REMARKS/ARGUMENTS

Amendments to the Drawings:

Fig. 2

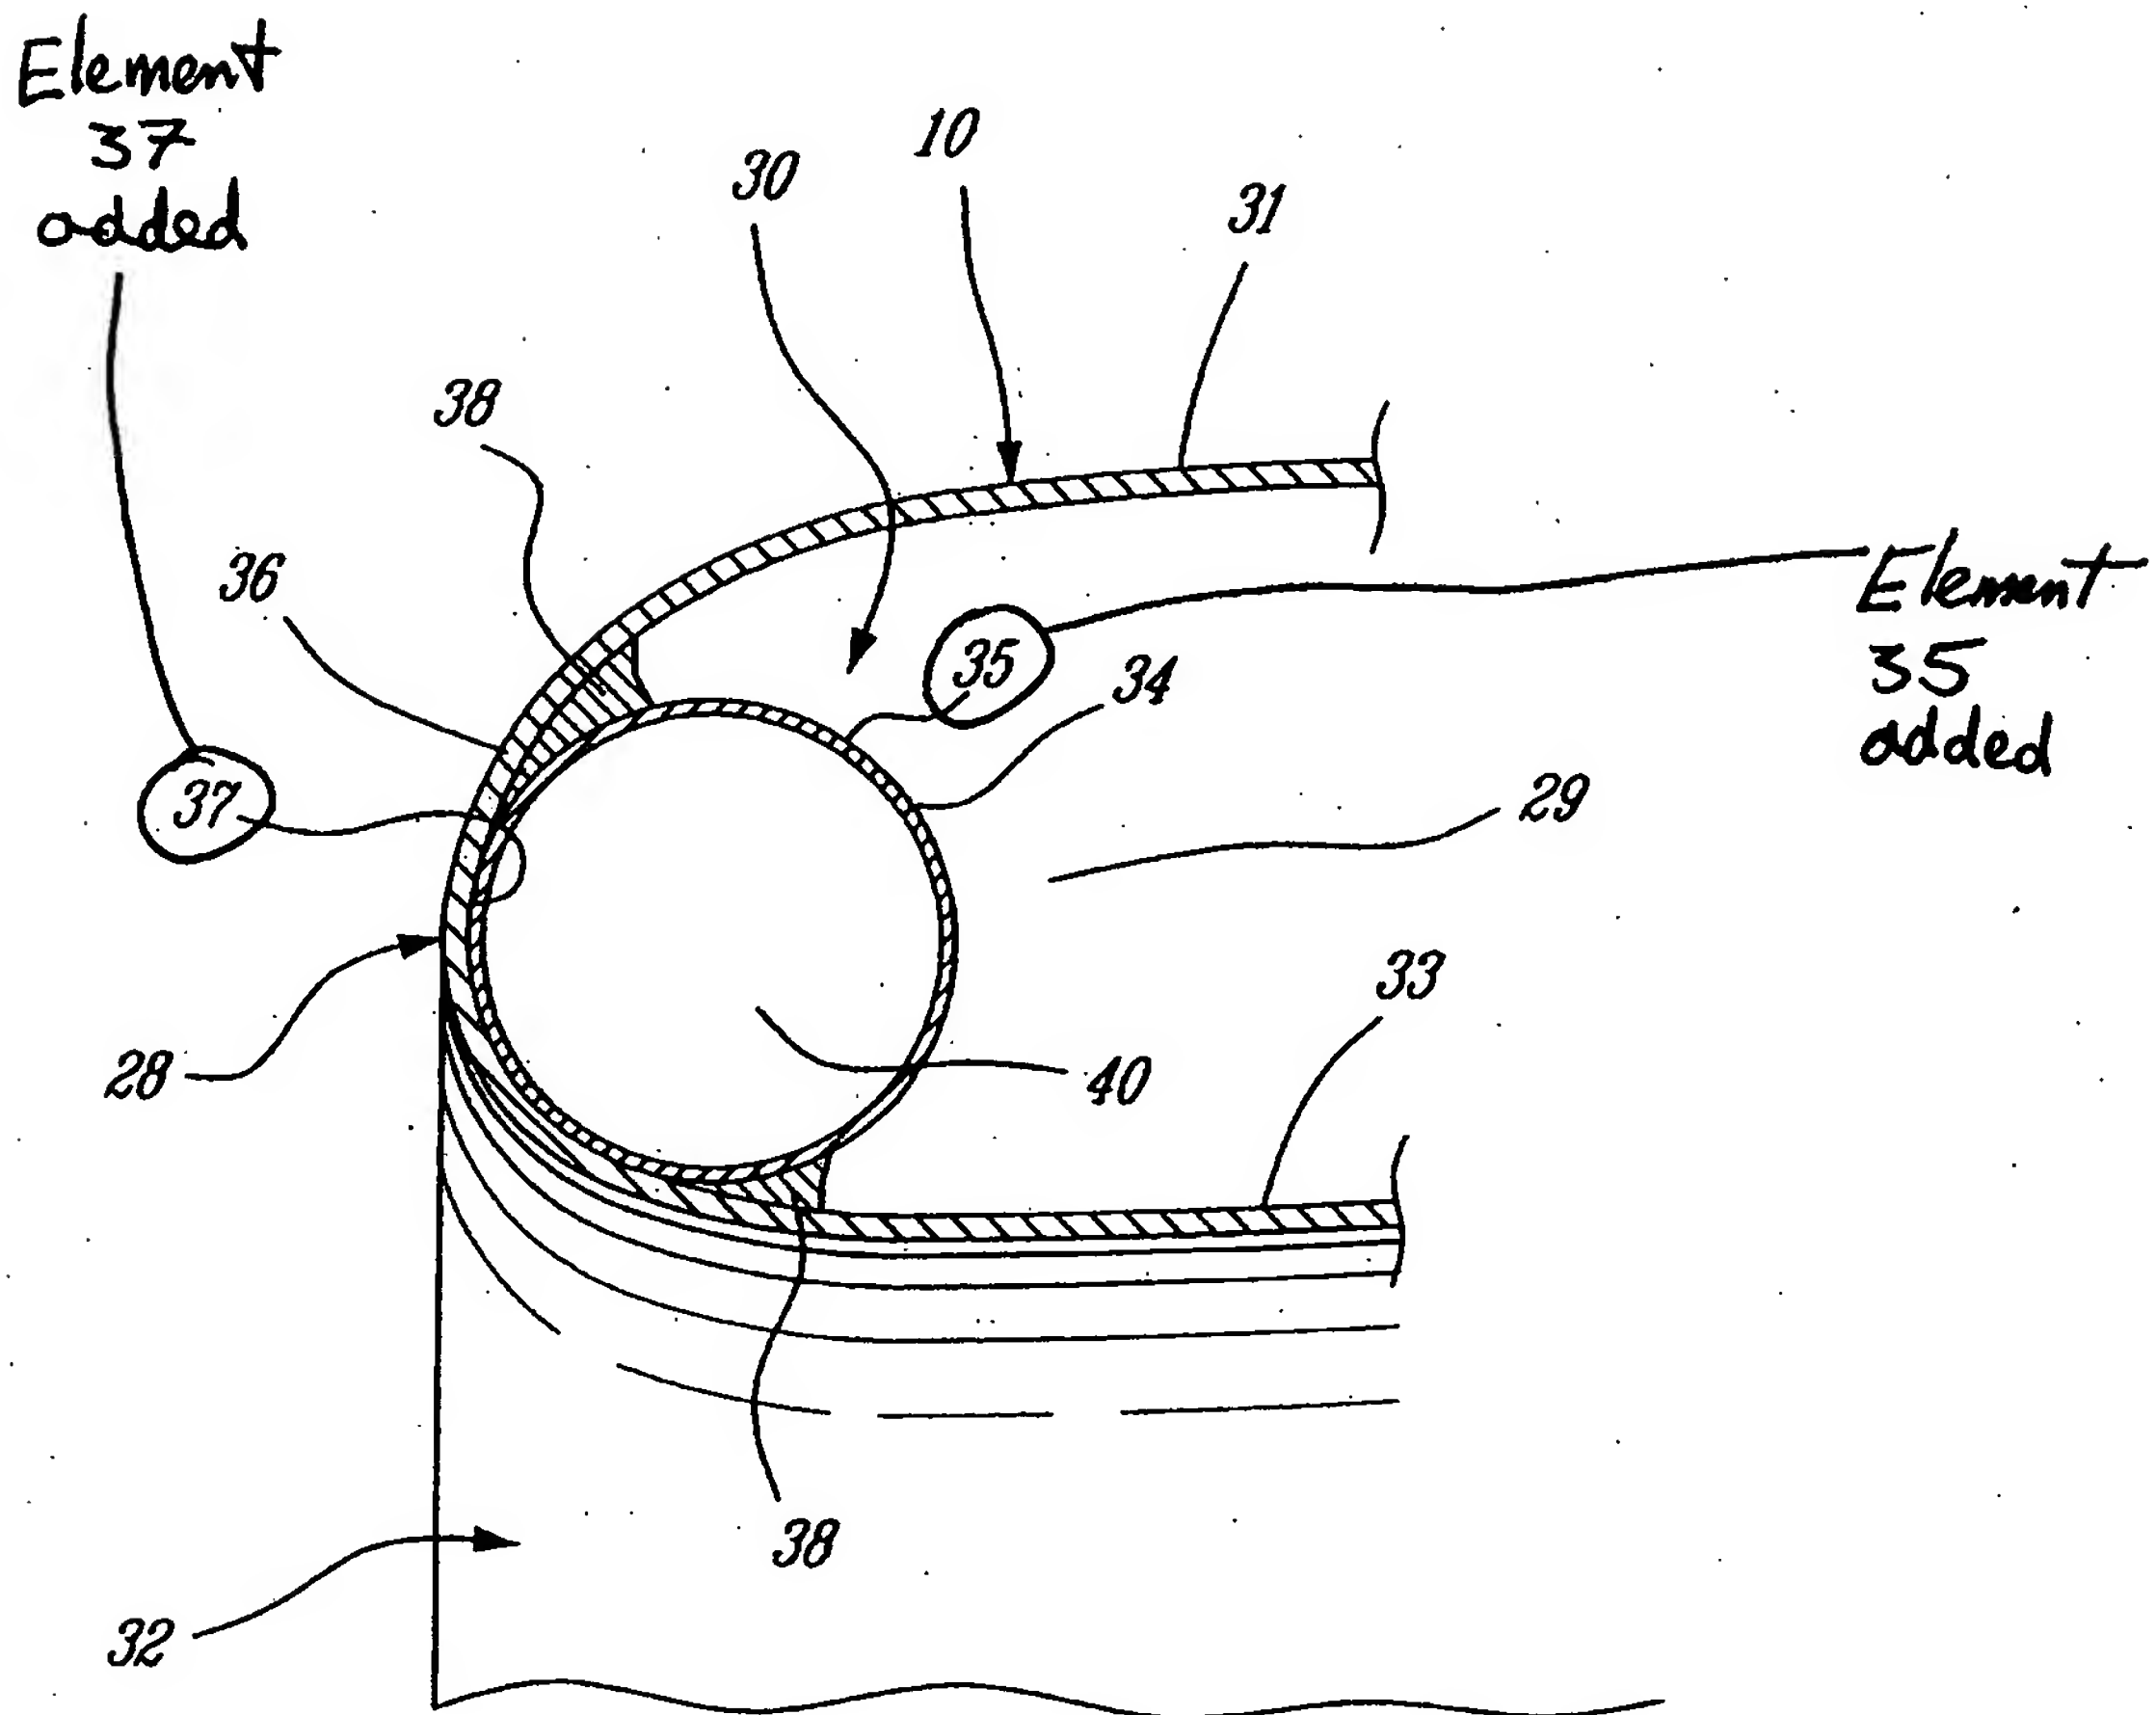
The drawings were objected to under 37 CFR 1.85(p)(5), for failing to include the reference numerals 35 and 37 referred to in paragraph [0021] of the specification. Accordingly, amended Fig. 2 as enclosed herewith has been corrected to include reference numerals 35 and 37, respectively identifying an outer wall of the tube 34 and an inner surface of the annular sheet metal lip 36. Reconsideration of the objection to Fig. 2 is therefore anticipated.

The attached sheet of drawings includes changes to Fig. 2. This sheet, which includes only Fig. 2, replaces the corresponding original sheet comprising Fig. 2. In Fig. 2, previously omitted reference numbers 35 and 37 have been added.
